Application Note

Adapting the MPC106 PCI Bridge/ Memory Controller to Existing MPC105 Systems

This document describes how to use the MPC106 in systems designed for the MPC105. The principal differences between the MPC105 and the MPC106 are as follows:

Figure 1. Cache Conversion for Internal Byte Decodes

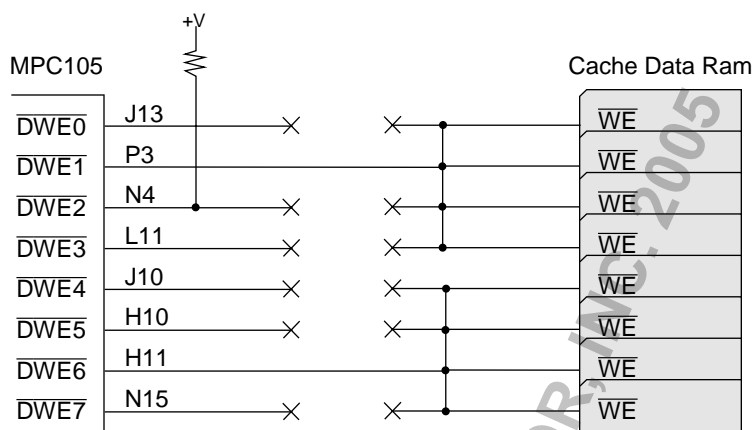
The MPC106 has had numerous changes to the cache controller. In some instances this is simply a renaming of previous signals, but several have been reused for quite different purposes. In particular, some versions of the MPC105 provide eight byte-write enables ($\overline{DWE0}$ – $\overline{DWE7}$) for the secondary cache controller, while earlier versions expected these signals to be created by an external PAL. The MPC106 has only three write enables ($\overline{DWE0}$ – $\overline{DWE2}$). These are actually identical signals, buffered to reduce loading, and cannot be used as byte enables.

If the system in question uses the on-chip byte decode mode of the MPC105 (that is, uses all eight of the $\overline{DWE0}$ – $\overline{DWE7}$ signals), then installing an MPC106 requires disconnecting the redefined \overline{DWE} signals (found at pin locations J13, N4, L11, J10, H10, N15), connecting pins P3 and H11 to the eight \overline{WE} signals of the cache data RAMs, and using the write mode $CF_WMODE = 0$. Pin N4 should have a pullup attached. Refer to Figure 1.
